Current Plan

What's wrong with this picture?

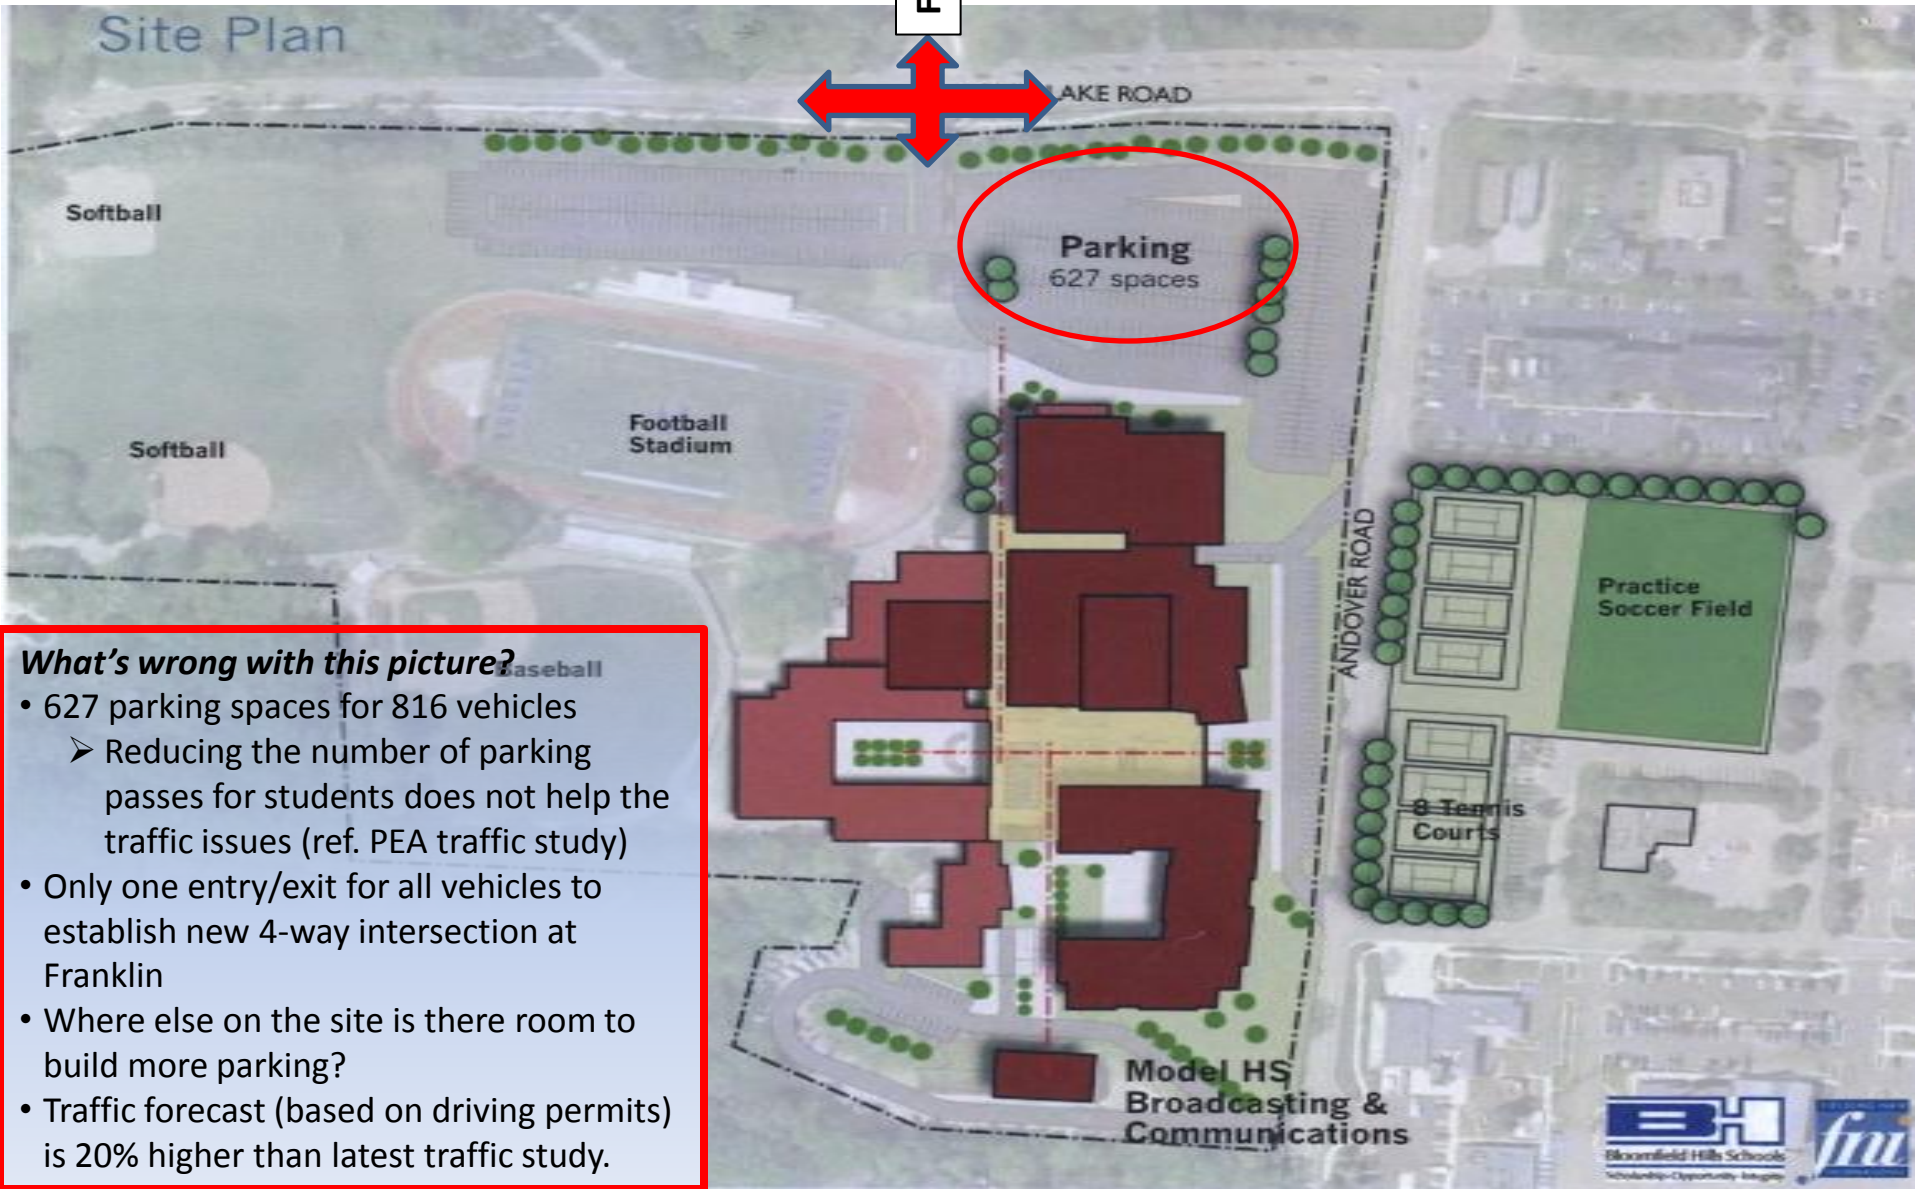
- 627 parking spaces for 816 vehicles
 - Reducing the number of parking passes for students does not help the traffic issues (ref. PEA traffic study)
- Only one entry/exit for all vehicles to establish new 4-way intersection at Franklin
- Where else on the site is there room to build more parking?
- Traffic forecast (based on driving permits) is 20% higher than latest traffic study.

- 627 Spaces
- 207 Employees
- 609 Students Parking Passes
- 189 Not enough spaces

Franklin / Long Lake Intersection
 One Entrance / Exit for 816 Vehicles
 School, Sports, Theater, Etc.
 No Entry / Exit onto Andover Road

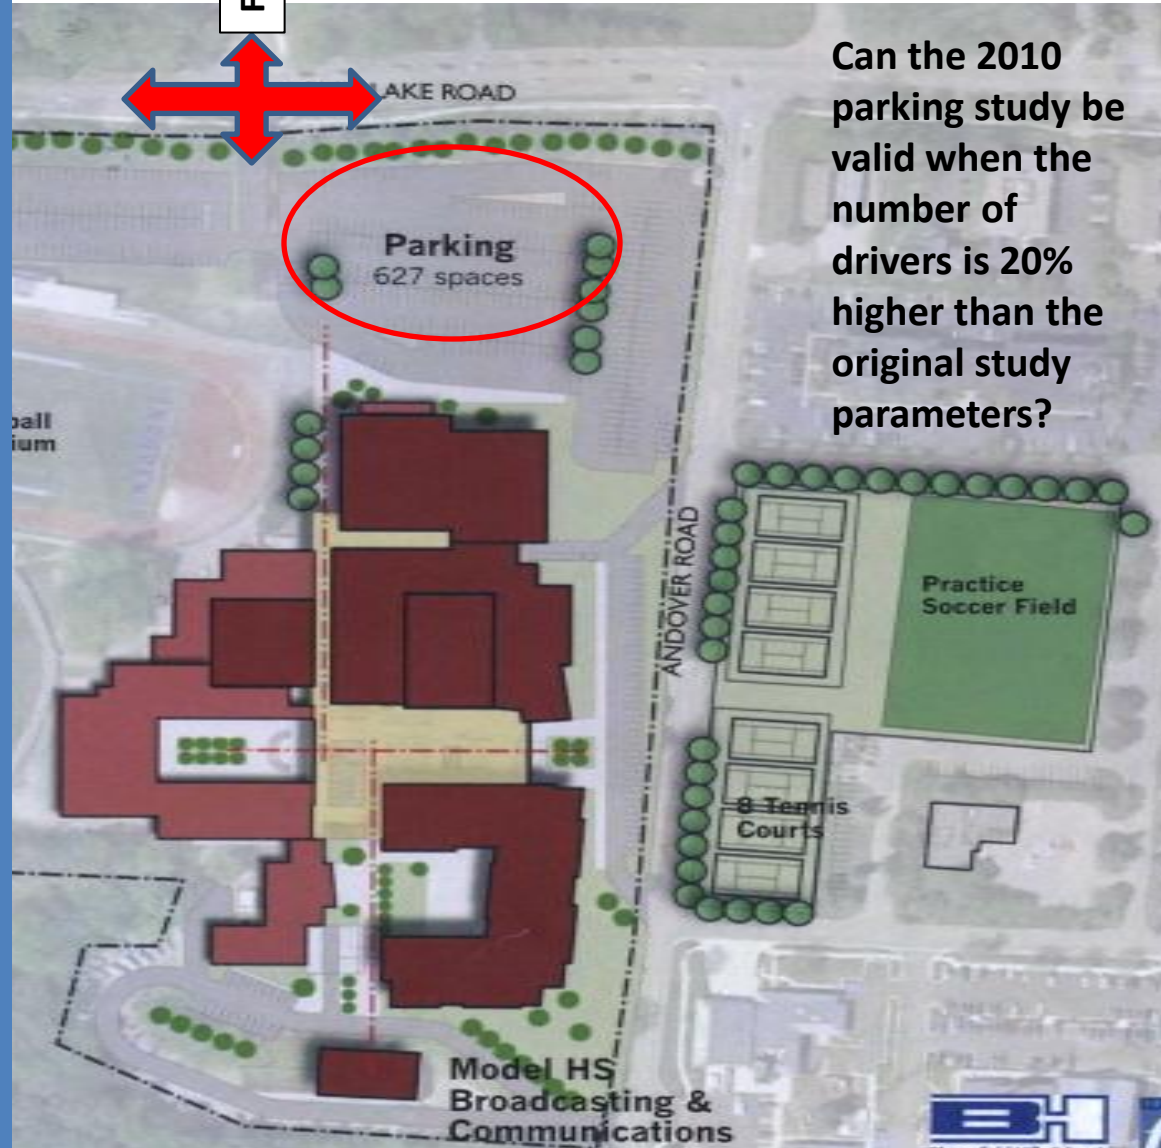
Q: PEA recommended only one driveway for student parking at Long Lake – would it be better to allow access from Andover?

A: No.

- Control of access means less chaos – and chaos causes traffic friction, and increased impacts.
- For the Andover site to function properly, student and parent drivers must be separated.
- We can retain parent access from Telegraph with a southern pick-up / drop-off.
